Proposal for Supplement 5 to the 02 series of amendments to Regulation No. 129

Submitted by the expert from Spain

Figure 1
Arrangement for testing a forward-facing device

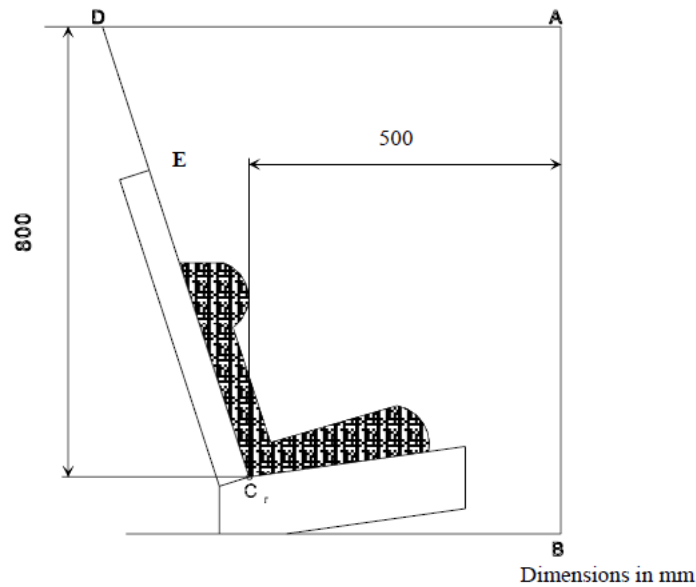
Head excursion: No part of the head of the dummy shall pass beyond the planes BA, DA and DE as defined in Figure 1 below. **However the head of the dummy may pass beyond the DE plane, if there is part of the child restraint structure, i.e. head pad or backrest, behind the head of the dummy, at the point the head passes the DE plane.**"

1. The assessment of the DE plane only applies to rearward facing Child Restraint Systems (CRS) in UN Regulation No. 44. The DE plane assessment remains relevant for rearward facing child restraints in UN Regulation No. 129.
2. For forward facing child restraints, there is often structure of the child restraint, (either head pad or backrest) behind the head of the dummy at the point the DE plane is passed. The energy absorption properties of this structure will have been tested using the test method described in UN Regulation No. 129. Therefore this structure would provide protection to the child's head.
3. It is therefore not necessary to assess the DE plane for forward facing child restraints that maintain structure of the child restraint behind the head of the dummy.
